TfNSW reference: WST20/00362/03 | SF2020/184623

Your reference: SSD-8950984

SSD-8950984: Response to the EIS Exhibition for the Burrendong Wind Farm

SSD-8950984 Burrendong Wind Farm Environmental Impact Statement review - CST Comments and requirements related to CRN corridor

Figure 3: Goolma Rd Crossing Operational rail Corridor from Orange Jct to Dubbo located at Montefiores NSW

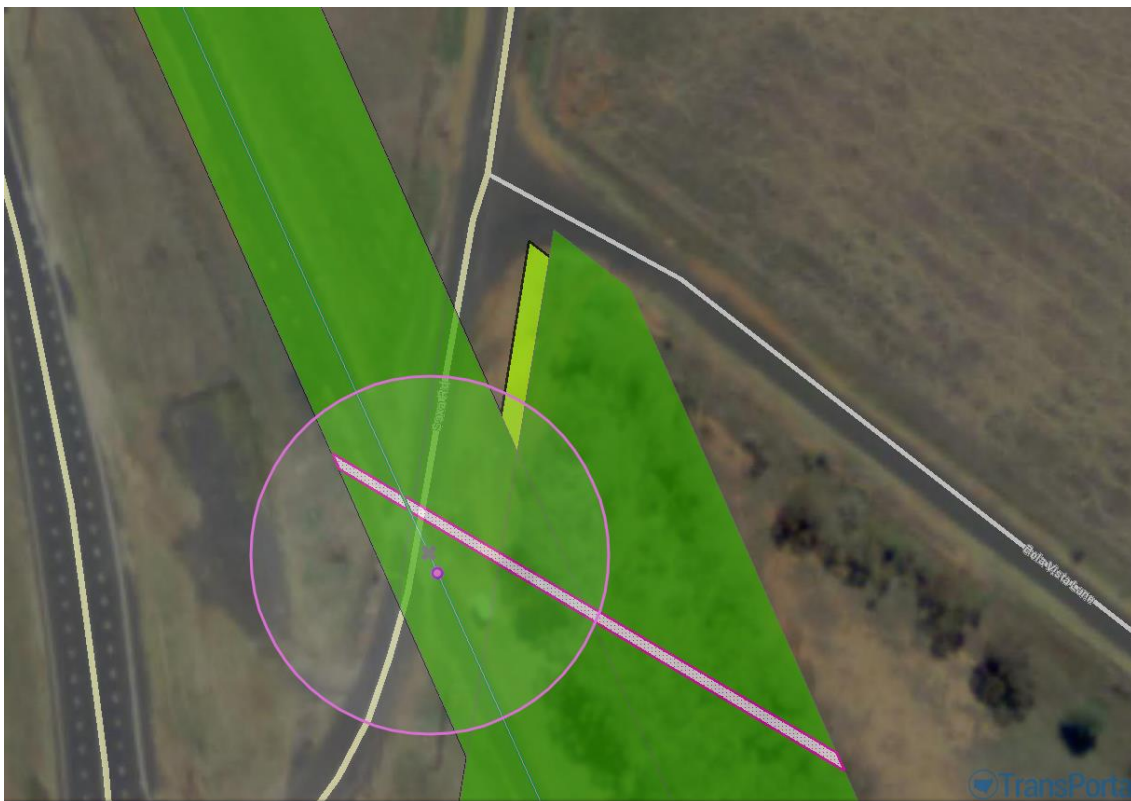
It should be noted that the proposed Heavy Vehicle and OSOM routes are crossing operational and non-operational railway corridor on CRN on seven (7) locations. These locations with aerial imagery are provided below from Figures 1 to 7.

The applicant must be aware of all crossings on CRN rail corridors located along the transport routes associated to the proposed development. Therefore, it is advised to include information on identified crossings on operational and non-operational CRN rail corridors in the EIS documents. In addition, if any adverse impacts to CRN corridor are identified in the EIS documents, the applicant shall seek approvals from UGLRL. Please also note that the applicant must adhere to the transport management and safety requirements of UGLRL and TfNSW for the matters involving CRN corridor.
